Avoidance criteria for cut-in situation

O I C A What does the current proposal regarding avoidable cut-in scenarios mean?

Example calculation of required latency

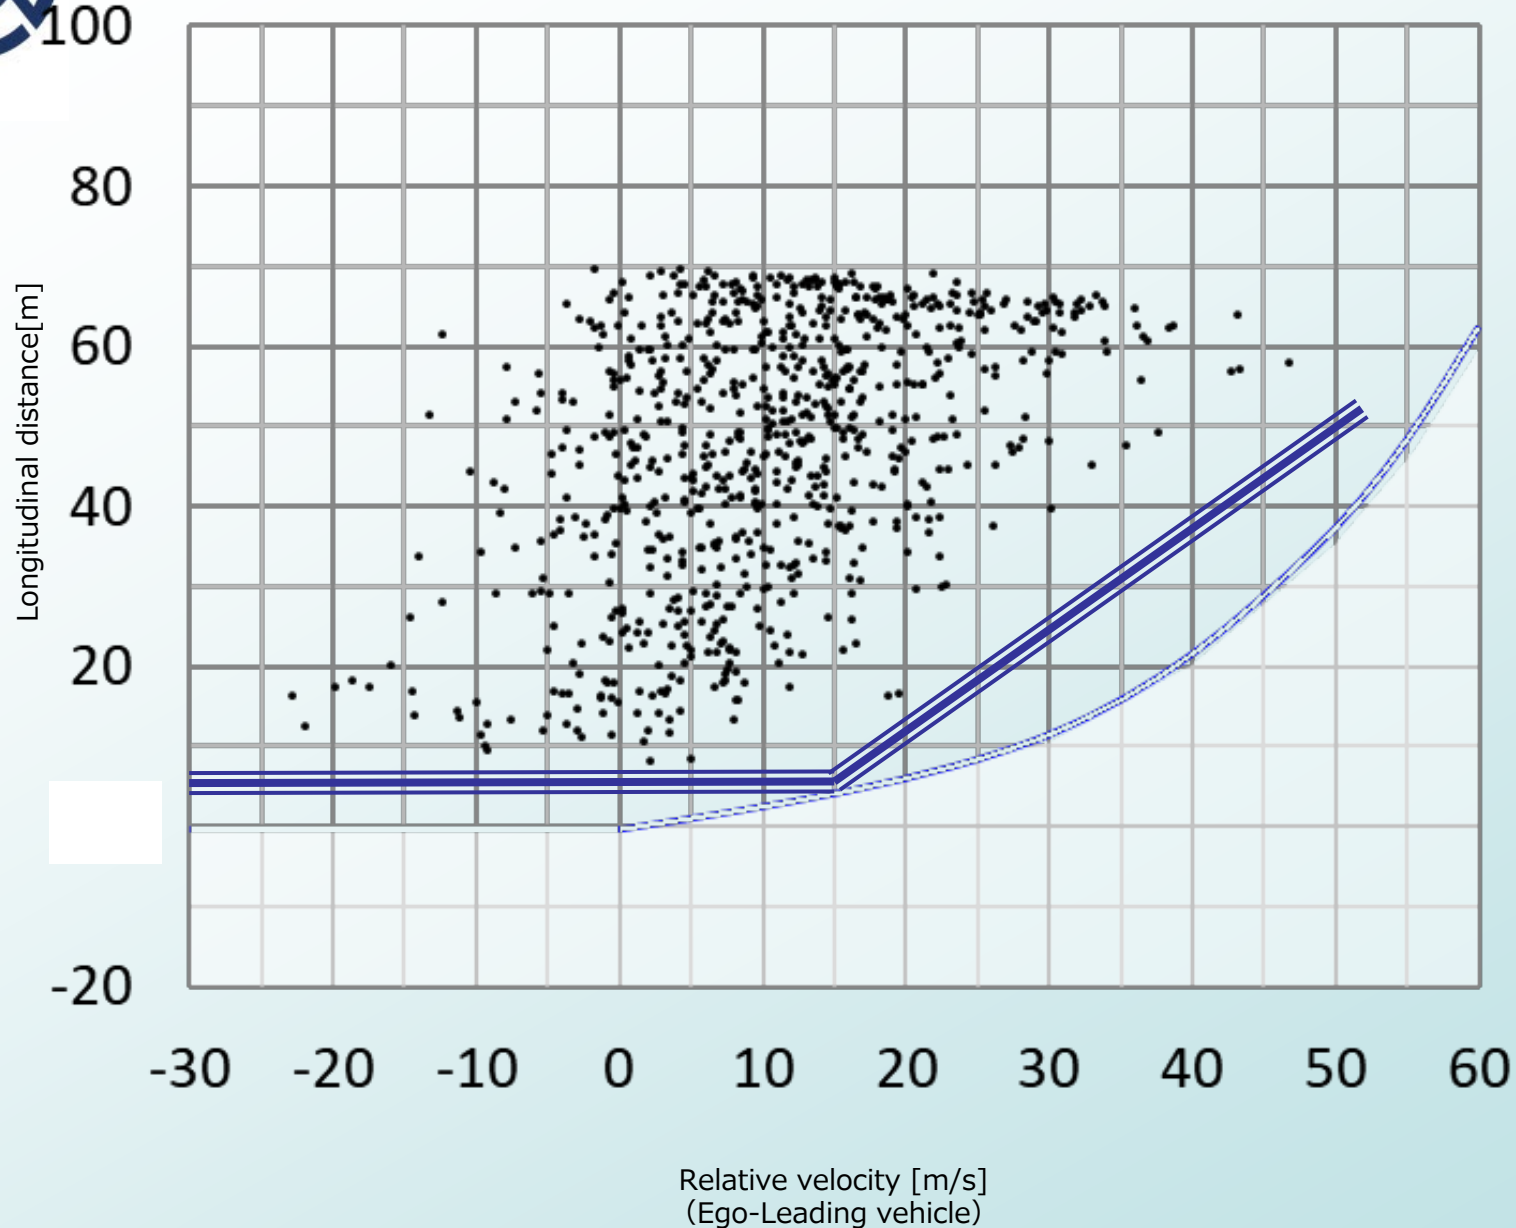
- **a vehicle that cuts out of this line of trucks, will not have been observed by the ALKS system previously**
- **Therefore greater detection time than 0,1s is needed to determine the behaviour of the cut-in vehicle.**

When Cut in vehicle's lateral speed is 1.5 m/s,

820ms (Latency from detection and signal processing) + **250ms** (Half the latency from the pressure build-up) = **1070ms**

→ **1.1sec**

➤ **Industry propose to introduce a lower cut-in threshold of 5m distance between the two vehicles.**

- 5.2.5.2. The activated system shall detect the risk of an imminent collision with a suddenly cutting in vehicle and avoid a collision,
- provided the cutting in vehicle maintains its longitudinal speed and
 - **When the distance between the vehicle's front and the cutting in road user's rear at the point in time when the outside edge of the respective front tyre of the intruding vehicle has crossed the inner edge of the lane marking of the ego lane by at least 30 cm is at least 5m.**
 - when the distance between the vehicle's front and the cutting in road user's rear corresponds to a TTC calculated by the following equation:

$$TTC_{LaneIntrusion} > v_{rel}/(2 \cdot 6\text{m/s}^2) + [1,1\text{s}]$$
